Access Compliance Report

Public Rights-of-Way

(Curb Ramps)

Intersection ID: 12972	Main Street: HAMORTON_PL	Cross Street: THOMAS_AV	Location: SE
ADA ID: 86021927424E	Ramp Type: PerpDiag	Initial Pass/Fail: Fail	Overall Compliance: No
Codes/Mitigation Info/Possible Solution		Field Measurements/Component Compliance	
Severity Score: 8.75

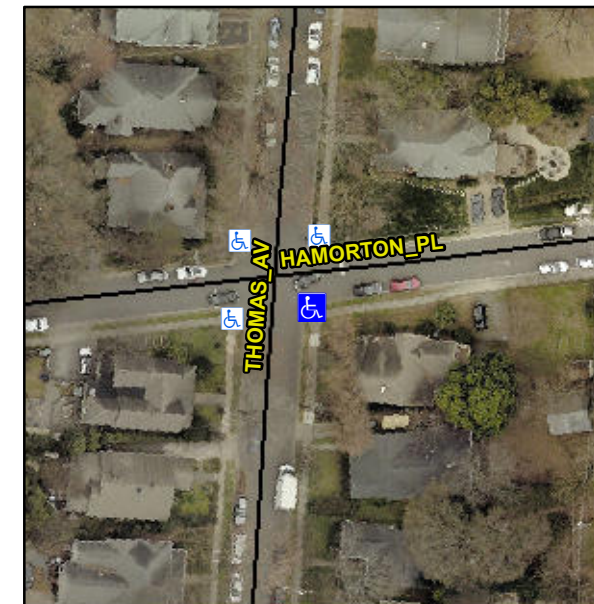
Not Found, R304.5.1

Compliance	Description	Data	Compliance	Description	Data
N/A	Ramp Length (in)	36.5	Yes	Ramp Slope (%)	7.5
No	Ramp Width (in)	47.0	Yes	Ramp XSlope (%)	1.0
N/A	Flare Type LT	N/A	N/A	Flare Type RT	N/A
N/A	Flare Slope LT (%)	N/A	N/A	Flare Slope RT (%)	N/A
N/A	Flare Traversable LT?	N/A	N/A	Flare Traversable RT?	N/A
N/A	Landing Length (in)	N/A	N/A	DWS Provided?	N/A
N/A	Landing Width (in)	N/A	N/A	DWS Contrast?	N/A
N/A	Landing Slope (%)	N/A	N/A	DWS Length (in)	N/A
N/A	Landing X Slope (%)	N/A	N/A	DWS Full Width?	N/A
N/A	Landing Curb? (Y/N)	N/A	N/A	DWS Offset (in)	N/A
N/A	Shared Landing?	N/A			
N/A	Gutter Ponding?	Yes	N/A	Gutter Slope (%)	N/A
N/A	Gutter Lip Ht (in)	2.5	N/A	Gutter X Slope (%)	N/A
N/A	Painted X Walk1?	No	N/A	Painted X Walk2?	No
	X Walk 1 Direction	To N		X Walk 2 Direction	To W
N/A	X Walk 1 Width (in)	N/A	N/A	X Walk 2 Width (in)	N/A
	X Walk 1 Slope (%)	2.1		X Walk 2 Slope (%)	4.8
	X Walk 1 X Slope (%)	3.1		X Walk 2 X Slope (%)	1.6

Remove & Replace Curb Ramp With Two New Directional Ramps or Equivalent.
